SUNDRY NOTICES AND REPORTS ON WELLS
Do not use this form for proposals to drill or to re-enter an abandoned well. Use form 3160-3 (APD) for such proposals.

8. Well Name and No.
JONES FEDERAL D 19. API Well No.
30-015-10278-00-S210. Field and Pool, or Exploratory
LUSK11. County or Parish, and State
EDDY COUNTY, NM

** BLM REVISED ** BLM REVISED ** BLM REVISED ** BLM REVISED ** BLM REVISED **

**PROPOSED
P&A IF CANNOT RESTORE CASING INTEGRITY**

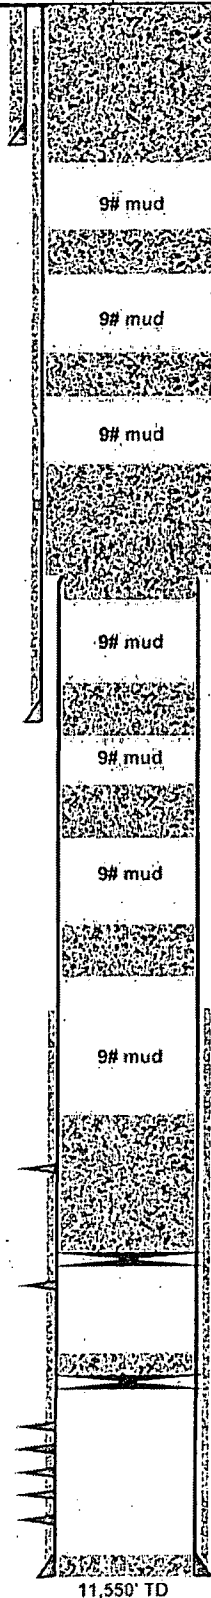
* Add: Perf & SQZ Class C From 3990'-3850'. WOC Tag.

** At cut-off verify cmt to surface all annulus. Remedial
cmt may be required 8 5/8" x 13 3/8" annulus. 50'-Surf.*

*Remedial cmt may be
Required @ cut-off.*

Proposed: *Perf/SOZ 3990'-3850'*
1. Spot 30 sx cement from 3,530' to 4,000'
WOC Tag

Proposed: *Perf/SOZ 4640'-4490'*
1. Spot 30 sx cement from 4,200' to 4,650'
(Delaware top @ 4,590') *WOC Tag*

Proposed: *Perf/SOZ 7070-6900*
1. Spot 30 sx cement from 6,650' to 7,100'
(Bone Spring top @ 7,020') *WOC Tag*

Ground Level Dry Hole Marker Required.
LAC Timing Stips Apply.
